Subject: BODY FLUSH / HANDGUN HOSE REEL VALVE OPERATION

Models: Camel **Affected Units:** 2021 Model Year or Newer

Description of Update:

Body Flush and Handgun Hose Reel Valves:

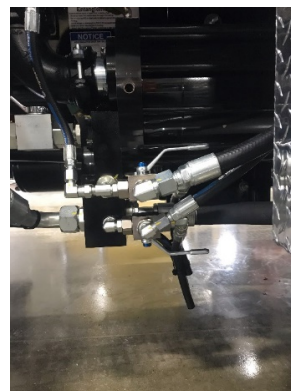
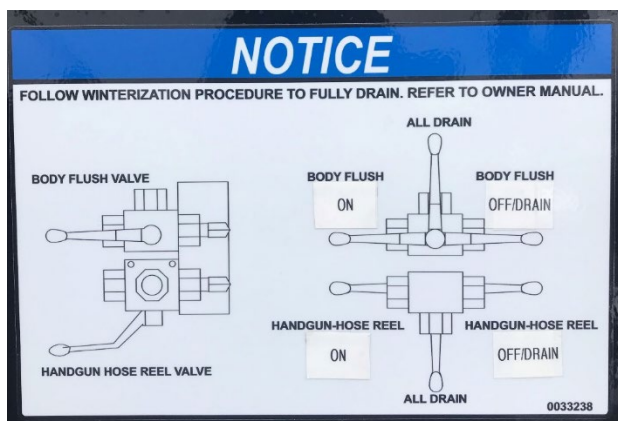
The new Camel Max HD design required that the water pump be moved forward 24” and outward 2”. This has resulted in a slightly different operation of both the body flush and handgun hose reel valves. The direction of both valves is reversed from previous models equipped with a single-piston water pump.

Note: In this picture both valves are in the Off / Drain position.
